3.4 CHILD CARE

Figure 3.4.2_Proposed Level 3 Plan - indicative child care layout

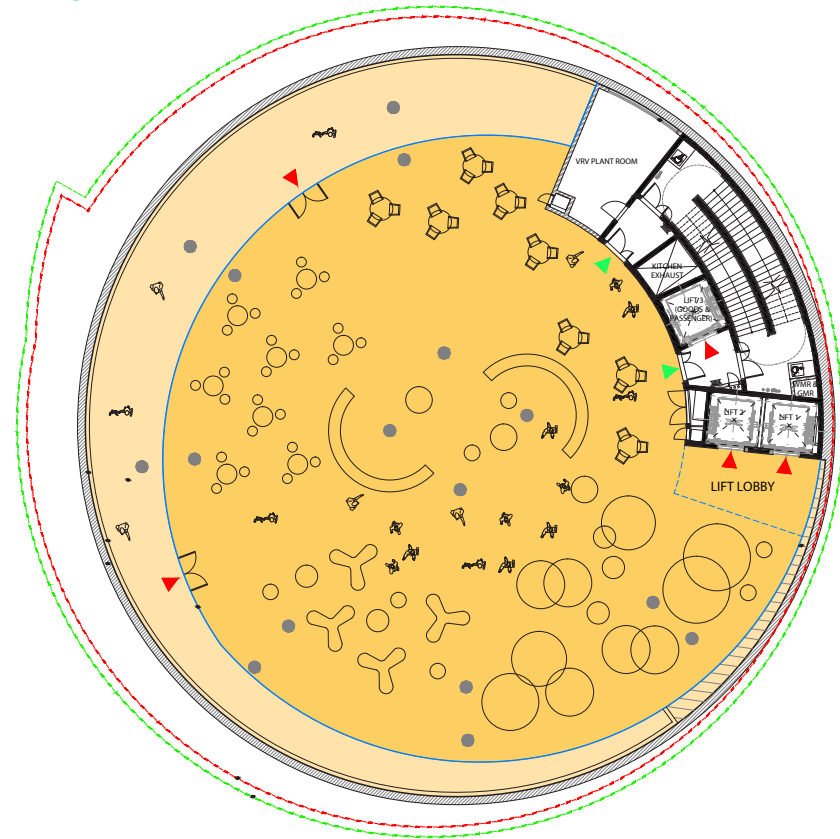
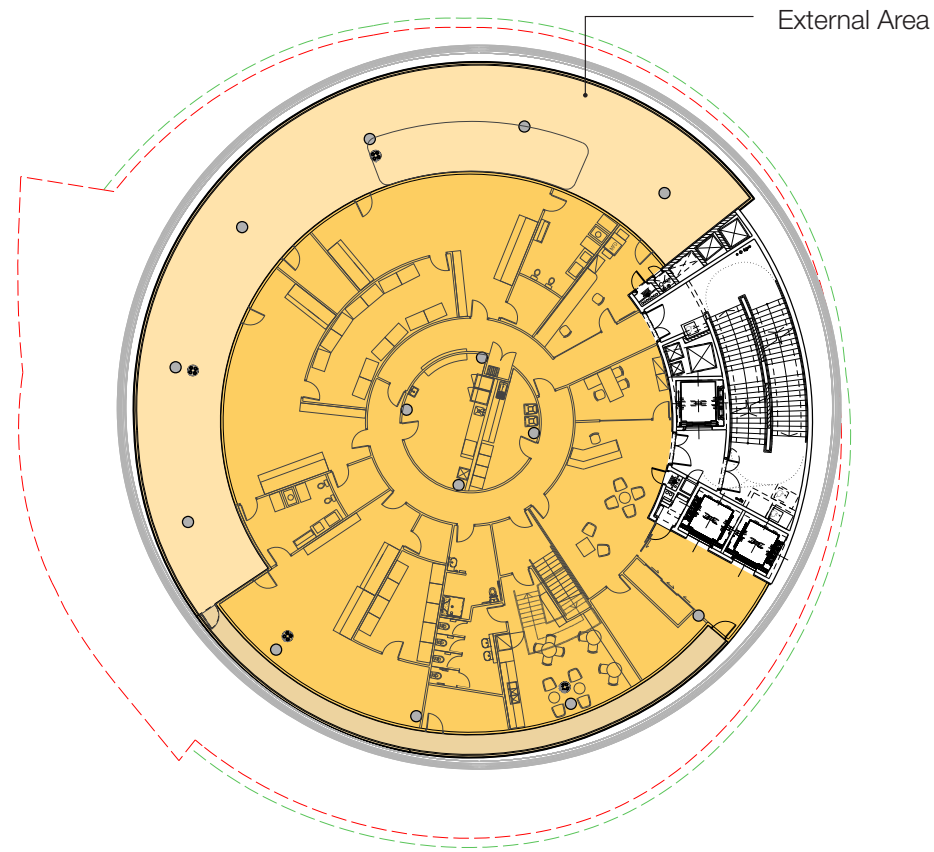
- *At this stage, the amount of outdoor space shown in the DA drawings (239sqm) is only sufficient for a 34-place centre as opposed to 90-place. The glazing line of the building will have to be moved dramatically.*

The external glazing line of both level 3 and 4 have been revised to create a combined unencumbered external area of 685sqm which is suitable for a 90-place centre based on DCP requirement of 7sqm of usable space per child. Level 3 has 268sqm of external space for 36 children (7.44sqm per child). Level 4 has 417sqm of external space for 54 children (7.72sqm per child). Refer to figures 3.4.1, 3.4.2, 3.4.3, and 3.4.4 for the indicative layout of the child care levels 3 and 4.

Figure 3.4.5_Levels of direct sun light penetration onto the child care terraces

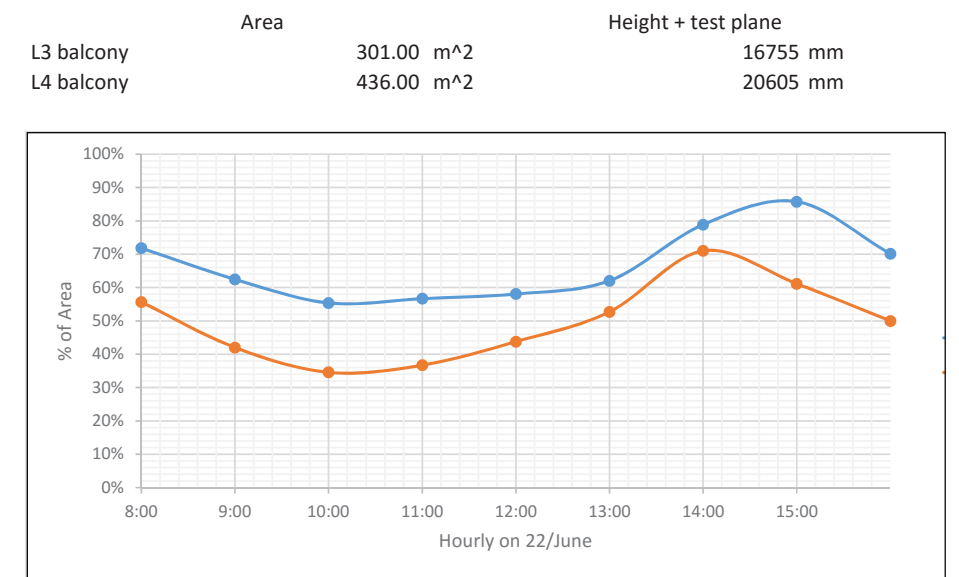
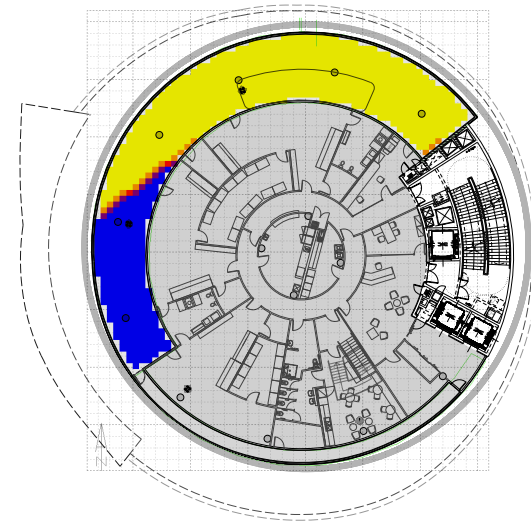
- *The child care centre will require detailed review in relation to acoustic treatments between floors, sufficient and useable outdoor space capable of accreditation, solar access to outdoor space, appointment of child care centre spaces per level, and practicalities of evacuation via fire stairs and lifts.*

Since the lodgment of the DA, extensive solar studies have been undertaken to help refine the size and orientation of the outdoor spaces. The outdoor spaces on both the child care levels receive adequate solar access between 9am and 3pm (and extended hours 8am to 4pm) on the 22nd June as per the Sydney DCP 2012 Section 4.4.4.3. Refer to Figures 3.4.5, 3.4.6 and 3.4.7.

Figure 3.4.1_ The building form has been developed to taper to the solar access plane to minimise the amount of shadowing to The Square.

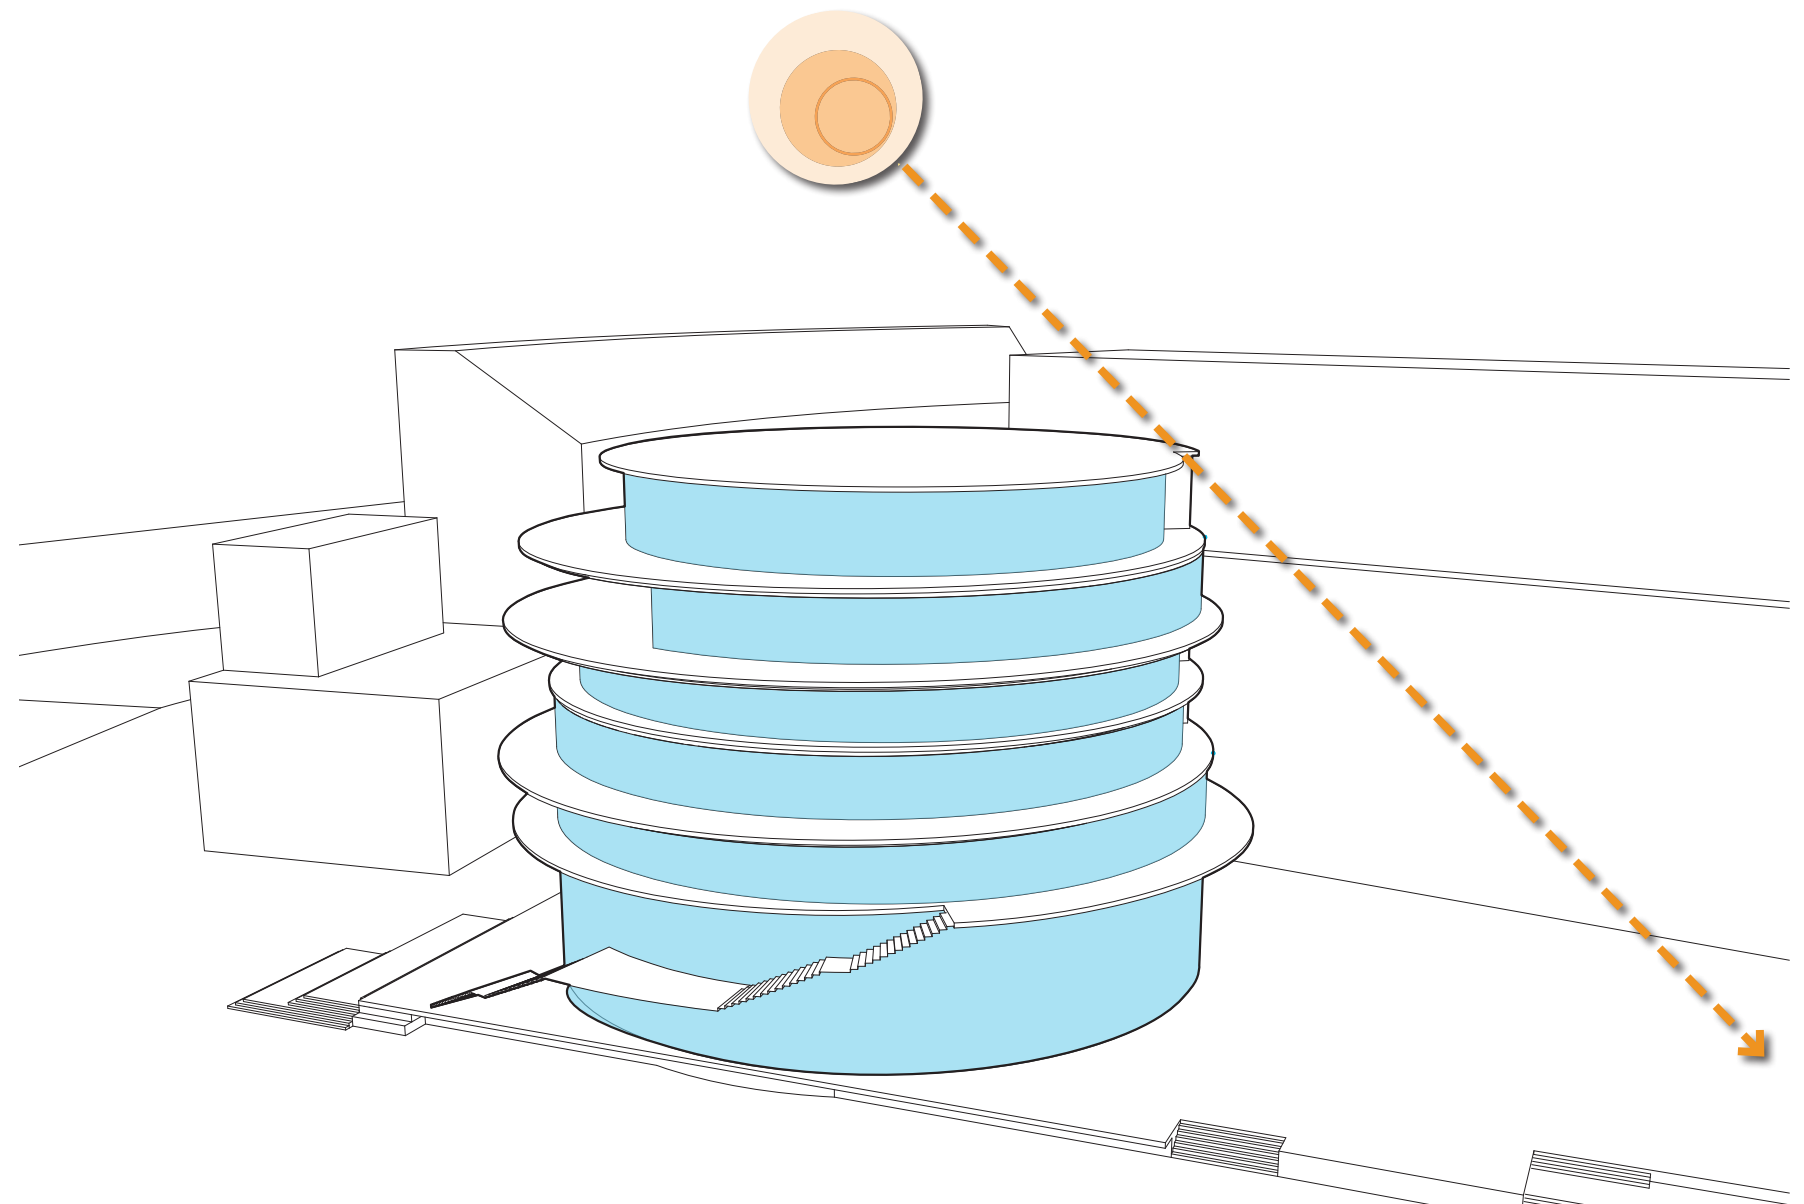
The Authority notes that the height of the proposed building (Darling Exchange) on the North Plot has increased by 5 metres. Any increase in building height should not create additional overshadowing across Haymarket Square during mid-winter. Further modelling is considered necessary in order to ensure solar access across Haymarket Square is maximised, especially the critical 12 midday to 2.00pm lunch time period during mid-winter and to confirm that the built form of the Darling Exchange does not dominate the public square.

The impact from the 5m increase in height has been assessed in great detail as part of the S96 modification to the Concept Plan which has now been approved. The building is entirely within this parameter plan and consistent with the overall parameter plan height control.

The building has been positioned to minimise the shadowing throughout the year. Refer to Appendix B - Shadow Analysis for further information.
